# **STEREO IMPACT**

PROBLEM REPORT PR-3017 Reichenthal 7/27/05

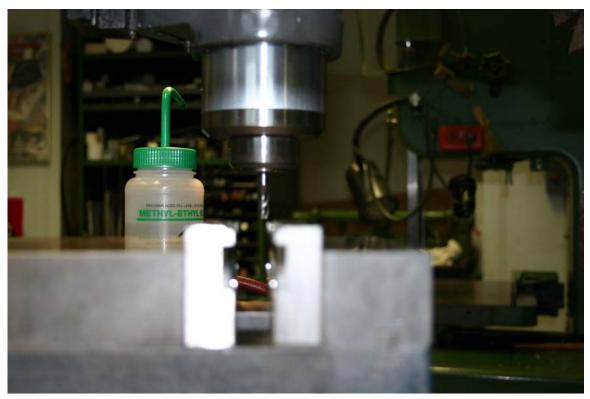
The 9 pin MDM connector on the SIT HVPS is not seated fully. There is approximately a 0.050 gap from a full connector engagement. This is due to the fact that the length of the jack post head protrudes past the connector shell. This problem is seen on both flight units. The jack post cannot easily be replaced because the hardware is terminated with nuts inside of the HVPS box. It would be a major effort to disassemble the SIT unit to disassemble the HVPS box.

Calculations of the worst case pin engagement due to the 0.062 gap is (0.012) worst case and (0.065) best case. In addition, without full connector engagement, the connector becomes more susceptible to humidity. This is not acceptable for flight.

$\Box$  Reworkx Repair $\Box$  Use As Is $\Box$  ScrapThe flange of the MDM connector of the mating harness was modified to allow for the jack post head to<br/>not protrude past the connector shell. Removed the clip (0.015") and milled the flange (0.025"). (Prior to<br/>milling the flange was 0.090"). The mounting hardware along with the area that was modified on the<br/>connector was covered with Uralane 5753. See attached pictures. The connectors on both flight units are<br/>now fully engaged.
